DESIGN REVIEW RECOMMENDATION

SDCI # 3034249-LU
6515 38th Ave S
Seattle, WA 98118

Applicant:
Cone Architecture
2226 3rd Ave, Suite 100
Seattle, WA 98121
Contact: Tim Carter

IMAGES FROM COMMUNITY OUTREACH

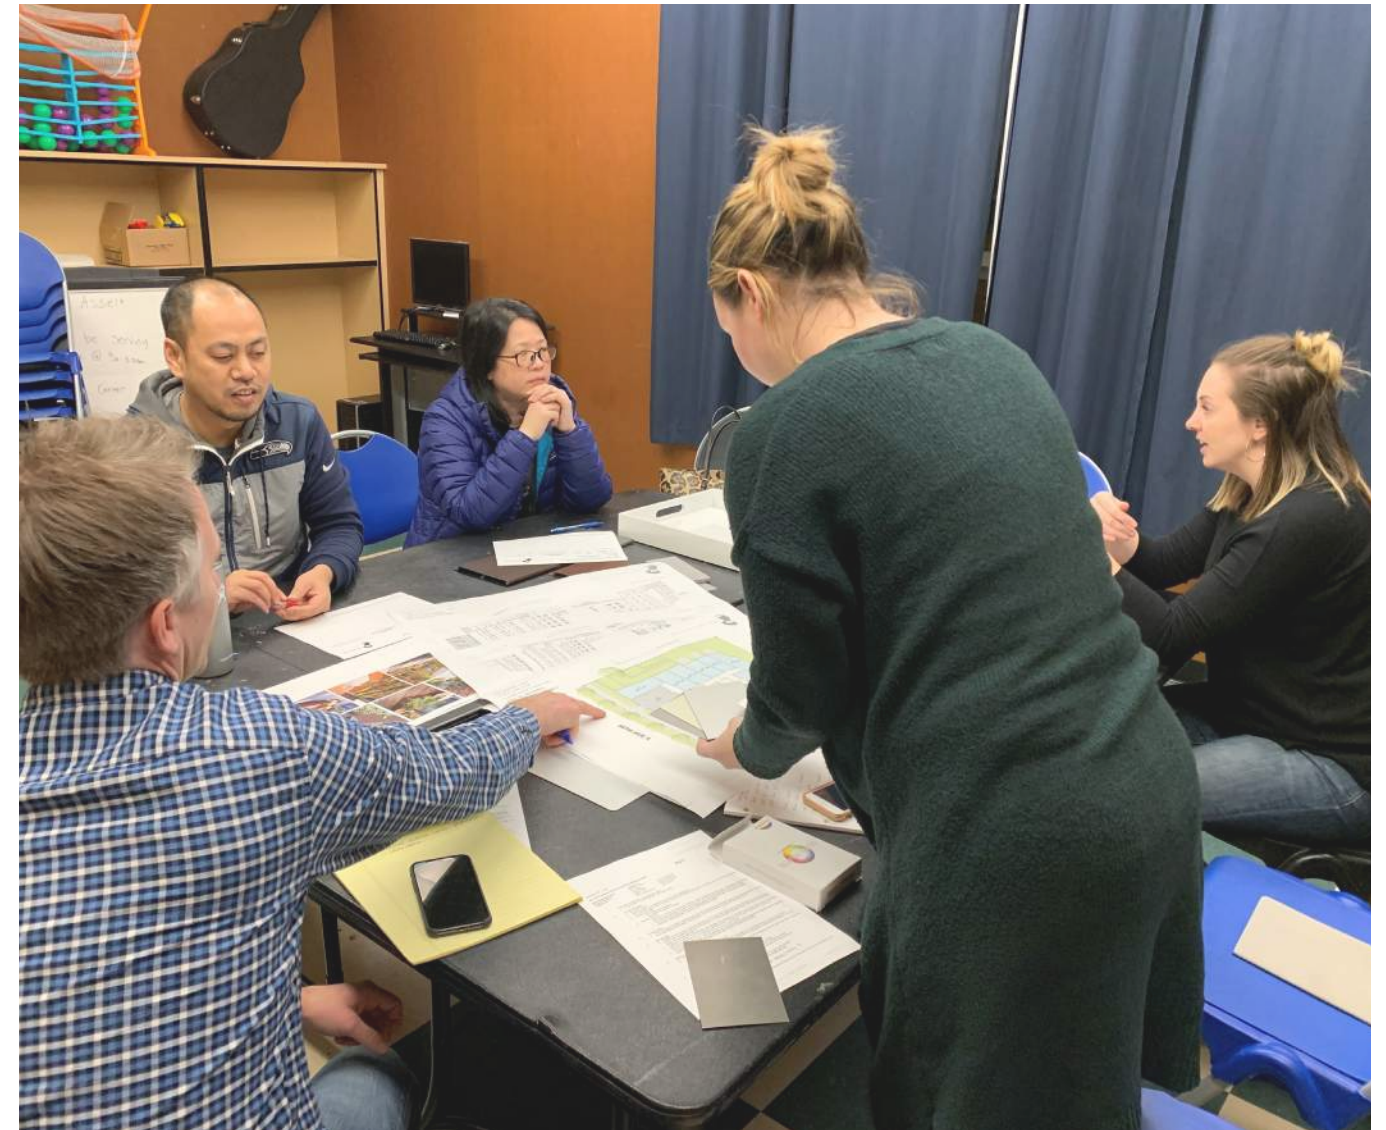
The Board noted the public comment given about the ineffectiveness of the early community outreach. While appreciative of their efforts and acknowledging the challenges associated with outreach, the Board requested the applicant continue outreach and dialogue with the immediate neighbors before returning for the Recommendation meeting. The Design Review Recommendation packet should document the outreach conducted, the feedback received and how it has been addressed through the design.

Per the boards guidance, additional outreach and feedback with the immediate neighbors was received at a second community outreach meeting held February 18, 2019 at the Van Asselt Community Center. The feedback received and how the proposal seeks to address the items discussed are detailed further into the design review packet.

At our second community meeting, we presented and asked for feedback from community members on the latest iterations of the siteplan, floorplans, and massing studies. Community members included the resident of the adjacent home to the northwest and the resident of the home two houses to the south. We also sought feedback on various material options and design solutions to activate the streetscape. Please see a more detailed break down of the community feedback on page 7 of this packet.

EDG MASSING NORTHWEST

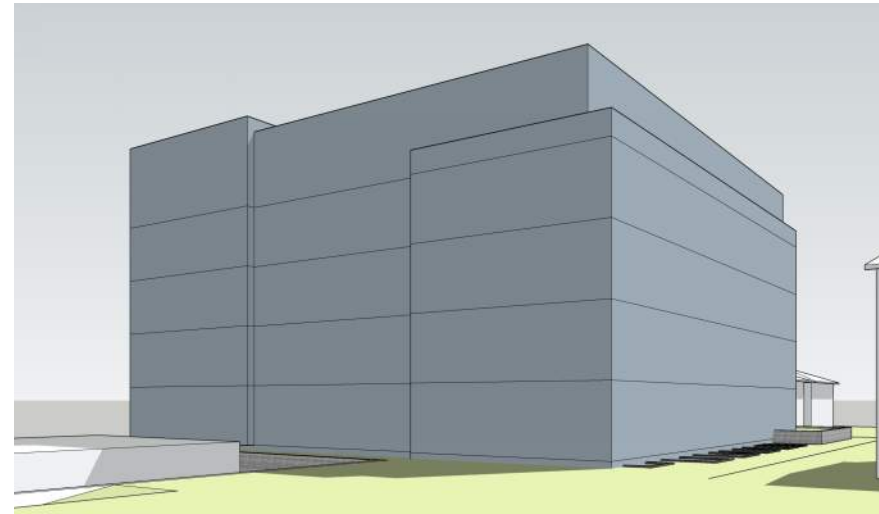
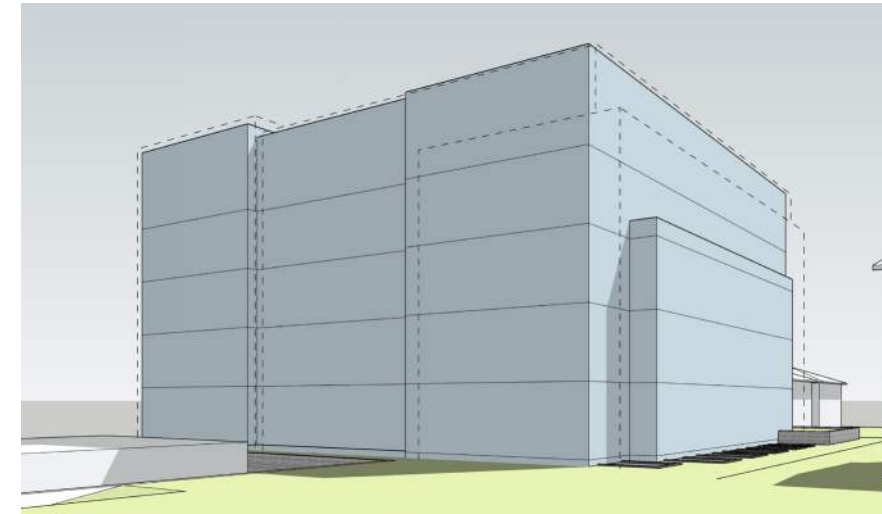
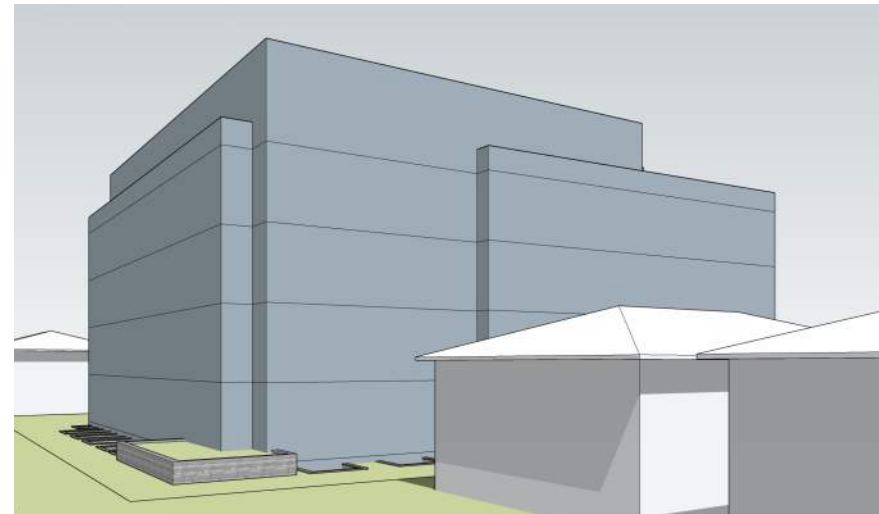
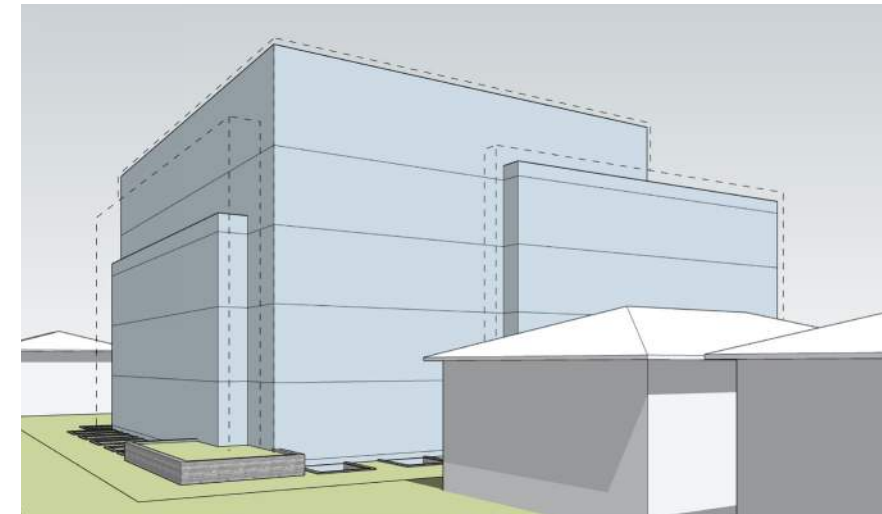
The Board supported the preferred massing option (option 3) as the basis for further refinement but stated concern with the massing response to the single family zone transition occurring along the west and south property lines and provided the following guidance: The Board provided guidance to be reductive at the zone transition and erode the edges of the massing as much as possible.

The response to the zone transition should include study of how material application, landscape buffers, screening, lighting and other design tools can be used to create human scale, lessen the imposing nature of the massing, and provide a more sensitive response to the neighbors.

The perceived height of the project has been reduced by designing all stair and elevator towers to be centrally located and pulled inwards from the property lines. The massing has been further reduced to be completely within the upper level setbacks and additional setback area has been provided at the edges of the building. The previously proposed departure is no longer requested. The west facade has been broken down to a smaller 3-story proportion to reduce the visual impact of the massing and relate to the scale of the adjacent townhomes to the west. Furthermore, this lower volume connects with the residential structures by incorporating architectural features such as juliet balconies and horizontal textured materials.

In response to the single family zone transition, the proposed massing has been reduced in height and bulk at the south and west facades. Wide landscape buffers will provide screening and reduce the perceived mass of the project. Materials that relate more closely to the adjacent residential neighborhoods have been applied to these facades. The project will use materials with texture and additional architectural features such as juliet balconies to break down the massing and create more human scale moments. Higher window sills at the northwest and southwest corners have been proposed to provide increased privacy for neighbors.

38TH AVE S APARTMENTS - ZONE TRANSITION SUMMARY

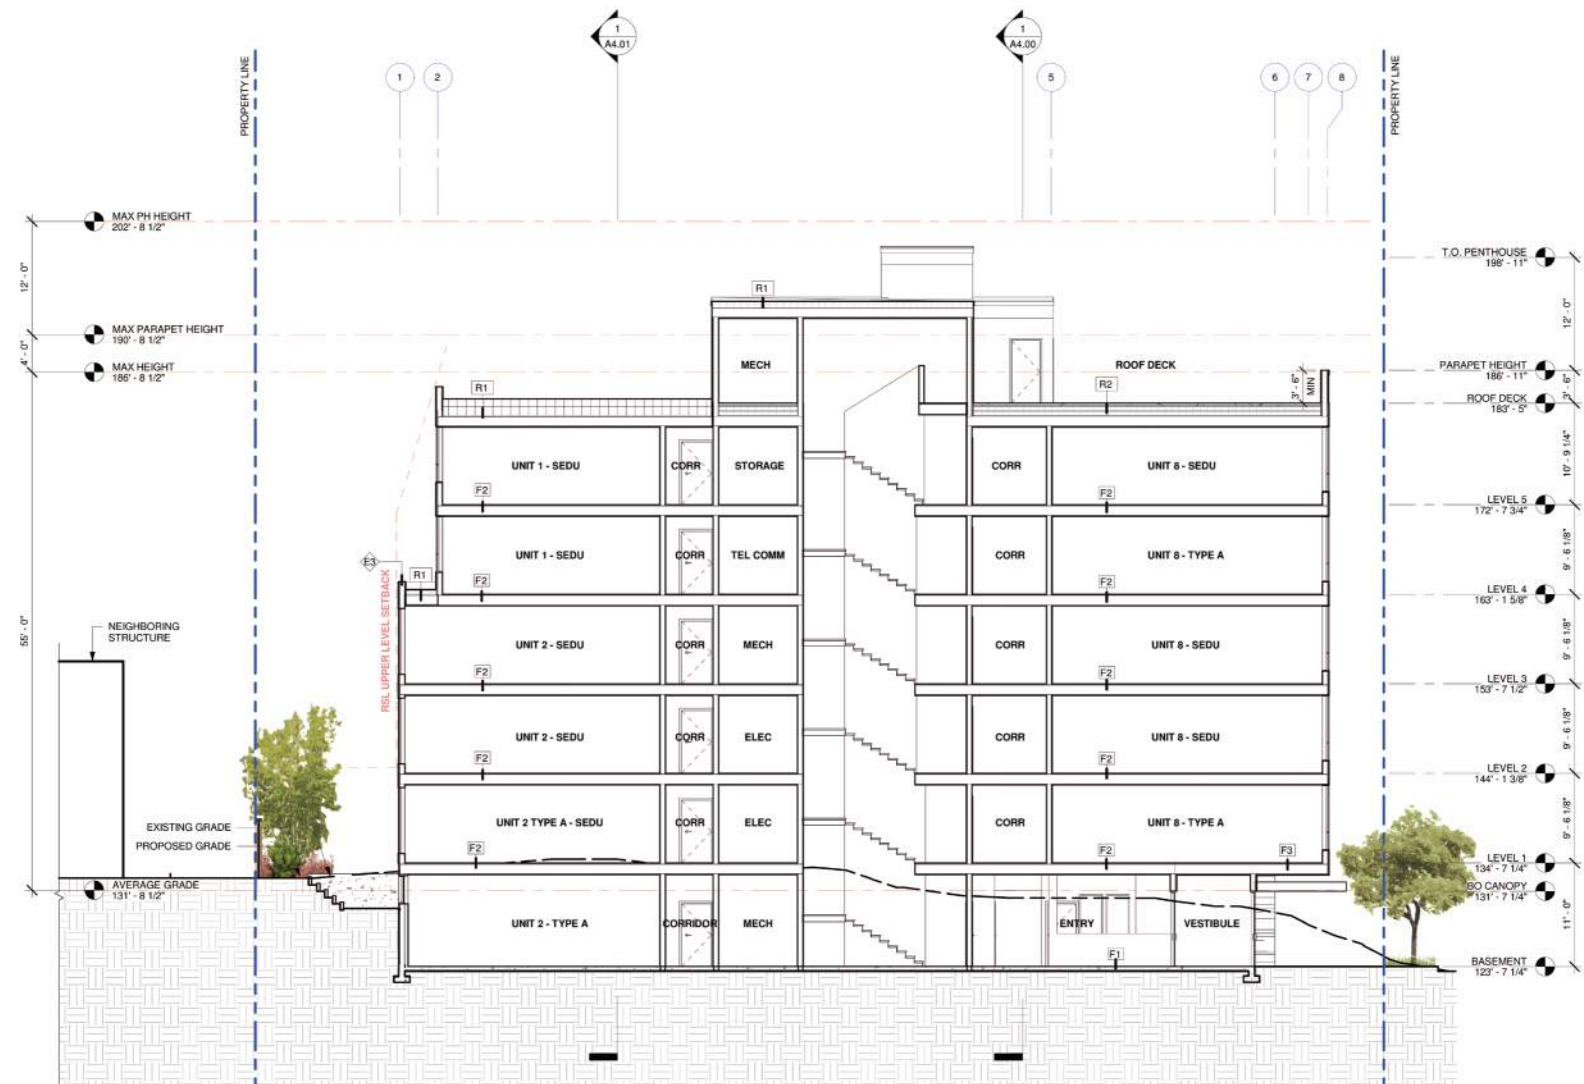
At the Recommendation meeting the Board would like to review a one-page summary of how the massing and design has responded to the zone transition.

A one-page summary detailing how the proposed massing responds to the current zone transitions has been uploaded alongside this packet.

VIEW OF NORTH COMMERCIAL BUILDING AND NORTHEAST CORNER

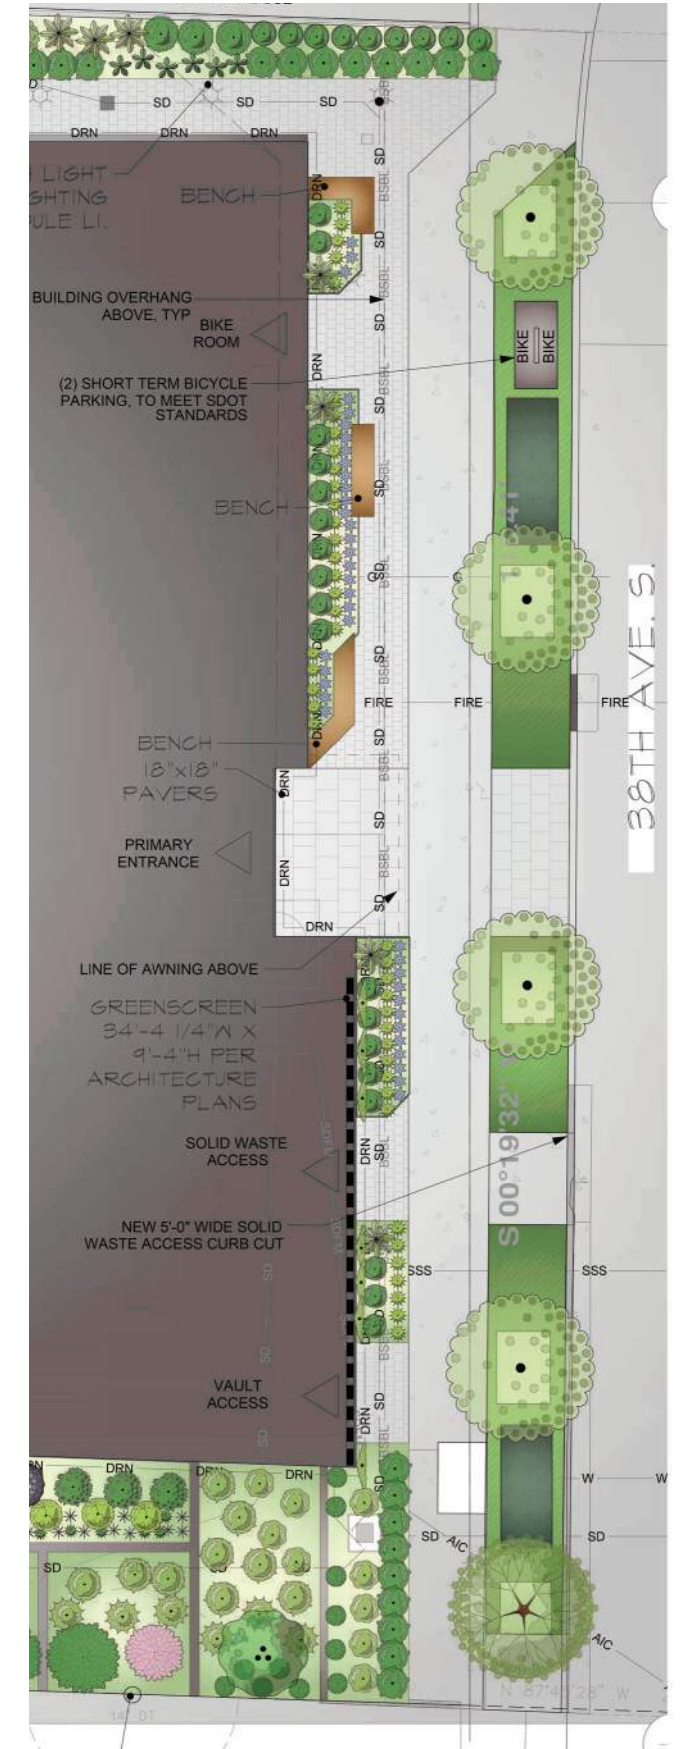
The Board also requested the applicant consider how the design and arrangement of uses could support the vibrancy of the adjacent local businesses.

The proposed design locates the most transparent and active uses at the northeast corner. This creates a semi-public space to support pedestrians that frequent the neighboring businesses to the north. A mix of hardscape area and landscape planters has been proposed to relate to the mixed existing conditions of the commercial area to the north.
